VEHICLE RECALL

G-03507
March 2003

SUBJECT: SAFETY RECALL (U.S., EXPORT)

Lower bunk webbing restraint bolts on 9200i and 9400i Pro-sleeper models built 1/21/2002 through 6/14/2002 with Code 16SCH.

**Figure 1: Lower Bunk Restraint Assembly Drawing
With Samples of Grade 5 and Grade 8 Bolt Heads**

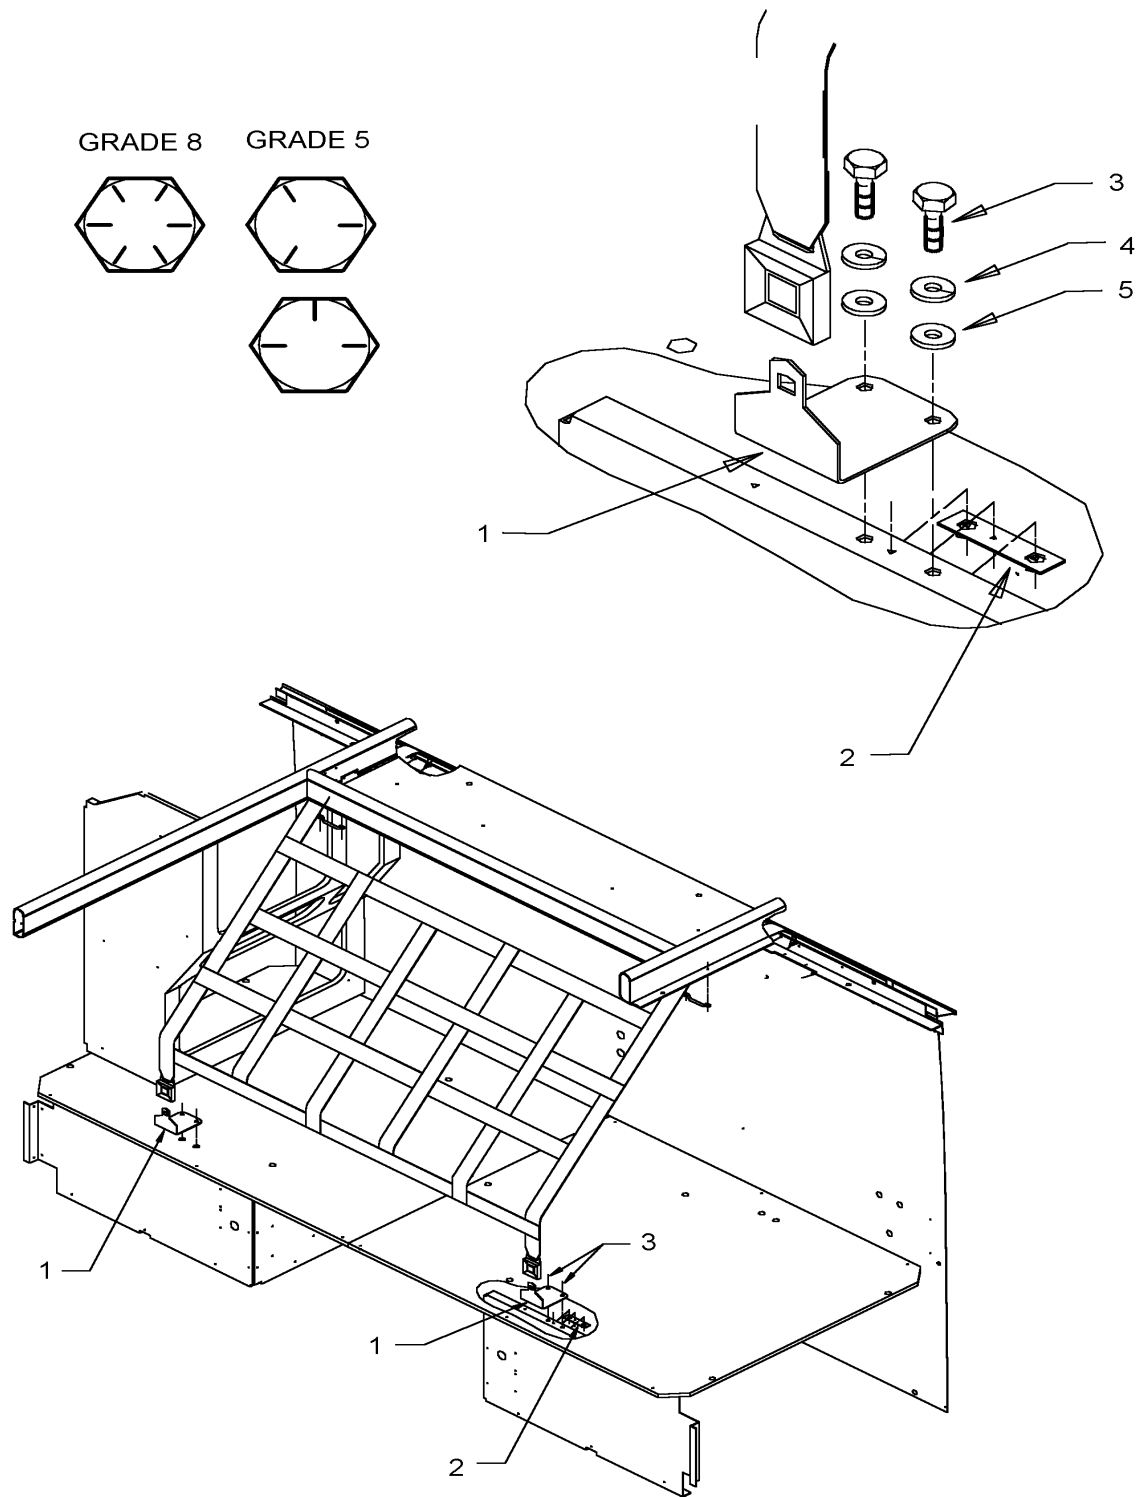
Four bolts hold the bunk webbing restraint latch brackets to the bunk base. These bolts were supposed to be grade 8 bolts but grade 5 bolts were installed in some vehicles. While this defect will not necessarily result in an accident, the original design intent of the restraint is not met with the grade 5 bolts. In the event of an accident the restraint may not contain the occupant as required by Federal Motor Carrier Safety Regulation 393.76 (Sleeper Berths) and **may result in property damage, personal injury, or death.**

1. **INSPECTION:** Inspect the bolt heads to determine if the 4 bolts holding the two restraint brackets to the bunk base are grade 5 or grade 8. Grade 5 bolts will have three dashes (lines) on the head of the bolt while grade 8 bolts will have six dashes (see samples of bolt heads in upper left corner of Figure 1, next page). There may also be some type of manufacturer identifying symbol on the bolt head; however, it is the dash marks (lines) that must be counted. If all four bolts are grade 8 then the inspection is complete and no replacement is required.

2. **REPLACEMENT:** Replace the grade 5 bolts with grade 8 bolts and be sure to install a lock washer and a flat washer as shown in Figure 1, next page. **Note:** The bolts screw into nuts mounted on nut plates (see Figure 1); therefore, replace the grade 5 bolts with grade 8 bolts **one at a time** so the nut plates will be held in place. The lock washer should be between the head of the bolt and the flat washer as shown in Figure 1. Torque all four bolts to (7.5-9.2 **FT-LBS**) or (90 -110 **IN-LBS**) or (10,2 -.12.5 **nm**)

1. Restraint brackets: two per vehicle.
2. Nut plate: one on each bracket.
3. Bolt holes/bolts: Bolt: 25487R1: grade 8: ¼ 20-UNC X 1 ½.
4. Lock washer: 27303R1: ¼ Regular.
5. Flat washer: 25707R1: ¼ Hardened.
